From: David Sroka - C16440
Sent: Monday, January 5, 2015 9:58 AM MST
To: Santosh Shetty - C21884
CC: Mark Bohm - C21577
Subject: RE: USB Mullti Host Bridge Questions.

From: Santosh Shetty - C21884
Sent: Monday, December 22, 2014 8:46 AM
To: David Sroka - C16440
Cc: Mark Bohm - C21577
Subject: USB Mullti Host Bridge Questions.

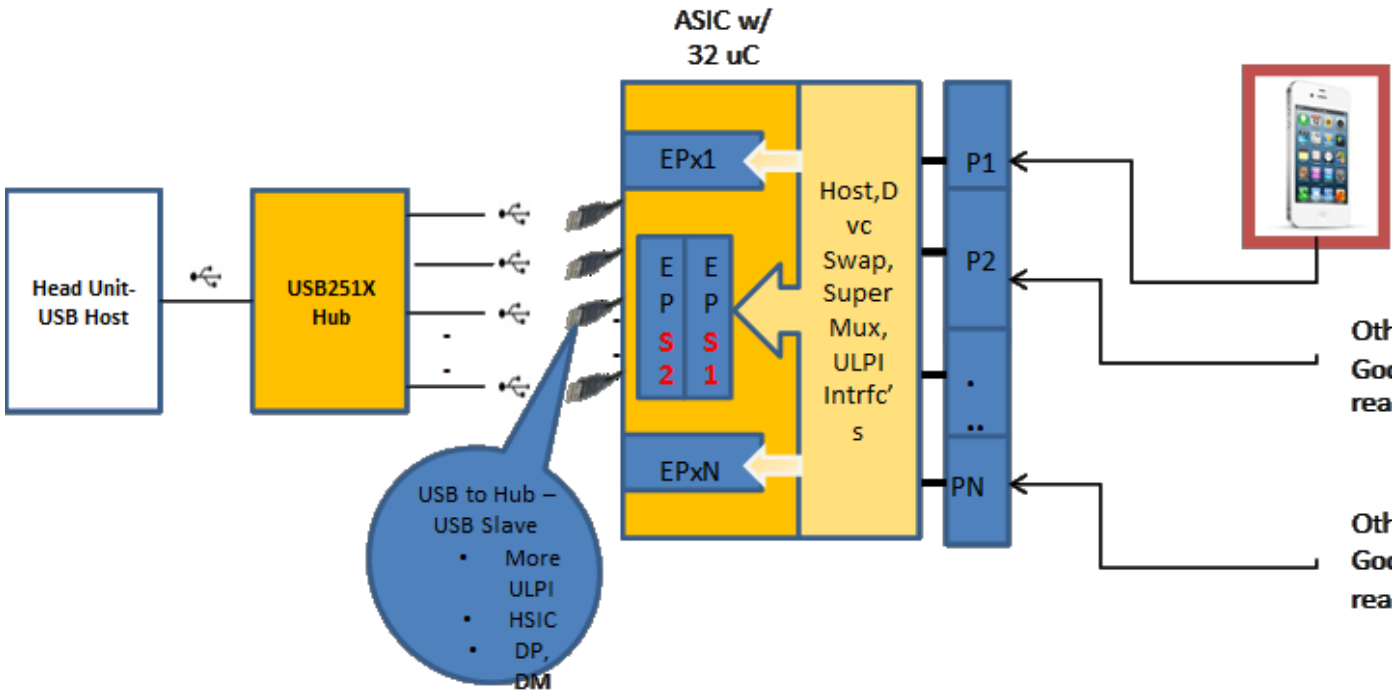
a) The Diagram above shows a USB HUB required for this solution to work , Is that the case .

b) P1/P2 – PN are shown as multiple devices connected to the ASIC, Is there list of USB device types that is supported ? or is it generic enough to support any USB device connected to one of the non-CAR play ports . What about Isochronous devices ?

Would be nice to understand, my current assumption is they only support a set of predefined USB devices ..

The diagram is our creation / interpretation of what Unwired is doing, and has not been confirmed.

This being said, in the Product Brief, I had put in a hub implementation and compound device implementation as options, and when we reviewed with Chrysler they definitely wanted the hub implementation. Note they have seen the Unwired solution. Separately we did receive information from sales about 2 months ago that Unwired solution would still need USB chips, namely, a hub and ULPI transceiver.

Lastly I think that Unwired has a 2 step approach, one with an FPGA and then the final, lower cost solution which would be an ASIC. This because Chrysler has said that they will not go to production with an FPGA solution, which means someone else is. Tecvox mentioned that GM is going to production with a FPGA. This because GM only has a USB Host port available on the head unit.
Dve
